UNITED STATES PATENT AND TRADEMARK OFFICE

10/598,728

Office Action Summary	Application No. 10/598,728	Applicant(s) JUNTUNEN, HARRI	
	Examiner Jeffrey O'Brien	Art Unit 3677

DETAILED ACTION

annotated
FIG. 1

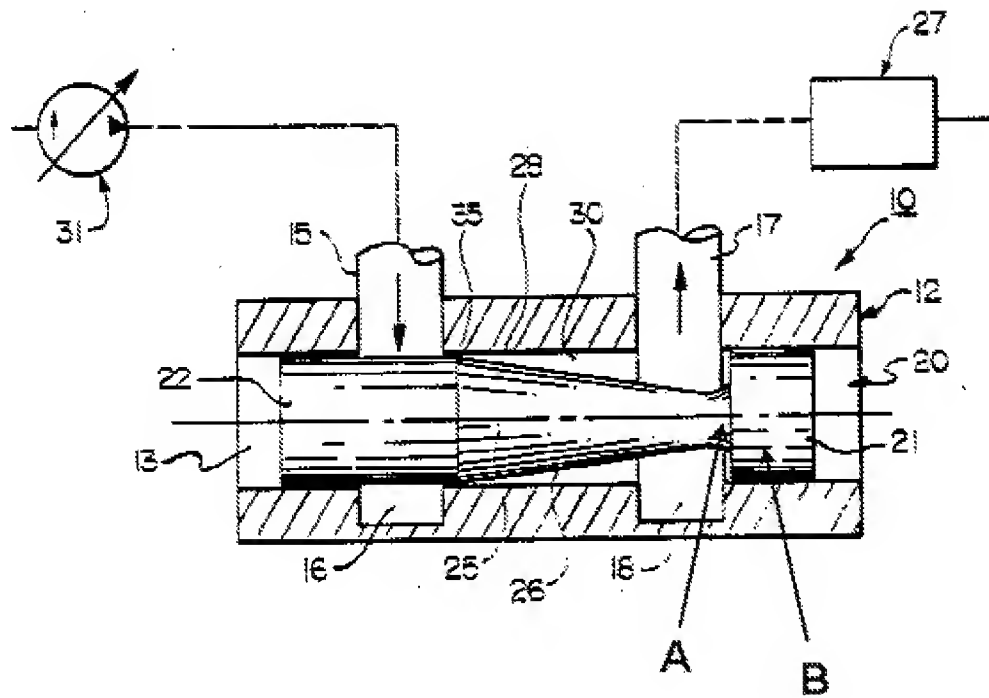
5. '919 teaches a valve having a beveled end (Fig. 1: 26) of a control part and at the beveled end of the control part, a support part (annotated Fig. 1: A) and a collar (B) that is a resilient material (wherein '919 is silent as to the material, but wherein bearings or collars are typically metal or plastic, both of which have some amount of resiliency) and can be placed around the support part (A) for providing a supporting surface that can be placed against the housing body. It would have been obvious to one of ordinary skill in the art at the time of the invention to apply the support part and collar of the valve of '919 to the valve of APA in order to allow for a close sliding relationship with the inner wall of the door closer body.

8. It is further noted that '919 teaches that "appropriate seals may be furnished to prevent fluid contained within the inlet and exit regions from passing between the bearings and the inside wall of housing opening." '919 is silent as to the type or structure of the seal, however these seals could be formed integrally (as forming integrally what was formerly separate is old and well known, see MPEP 2144.04) with the bearings/collar elements. Therefore '919 teaches collar members which compress or are capable of compression.
